August 22, 2007

SUBJECT: STAFF EVALUATION OF BWRVIP RESPONSE TO NUCLEAR REGULATORY COMMISSION SAFETY EVALUATION OF "BWR VESSEL AND INTERNALS PROJECT, EVALUATION OF CRACK GROWTH IN BWR STAINLESS STEEL RPV INTERNALS (BWRVIP-14-A)" (TAC NO. MC2738)

Figure 2. Times for Growth to 0.8h for Three Different Distributions of Stress Intensity Factor.

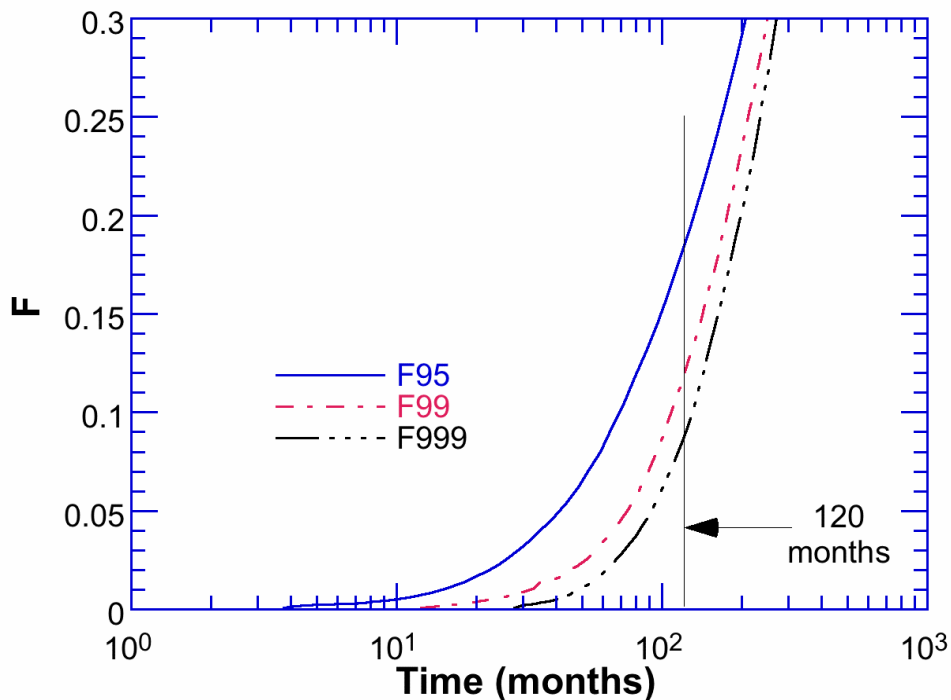
Monte Carlo calculations were performed by taking a sample from the failure time distribution and a sample from the crack growth rate distribution, and using the crack growth rate value to scale the time sample (which was computed using the BWRVIP crack growth rate 95th percentile correlation). The Monte Carlo samples can then be rank ordered to estimate the probability of failure, i.e., growth to 0.8h, by a given time. Calculations are shown in Figure 2 for cases where the time for growth to 0.8h corresponding to the H6a stress intensity distribution is taken as the 95th, 99th, and 99.9th percentile value of the distribution. For the 95th percentile case, the probability that the crack has grown to 0.8h through-wall is 0.17 and the probability that no cracking this deep would have occurred in any of the 26 cases is 0.007.

This is too low to be statistically plausible. For the 99th percentile case, the probability that the crack has grown to 0.8h through-wall is 0.11 and the probability that no cracking this deep has occurred is 0.05. While low, this is considered statistically possible and the conclusion is that the H6a K-distribution represents the 99th or higher percentile of the K-distributions observed in service. The value of [] months for the BWRVIP-14-A generic K-distribution and 95th percentile crack growth rate corresponds to the 25th percentile of the F99 distribution. Thus it would give conservative answers greater than 75 percent of the time. The crack depth would exceed 0.8h less than 11 percent of the time.

These results support the assertion in the BWRVIP letter dated September 12, 2005, that the combination of the BWRVIP-14-A generic K-distribution and the BWRVIP 95th percentile crack growth rate curve will provide reasonably conservative estimates of through-wall growth of cracks even though they may not be bounding in all cases.
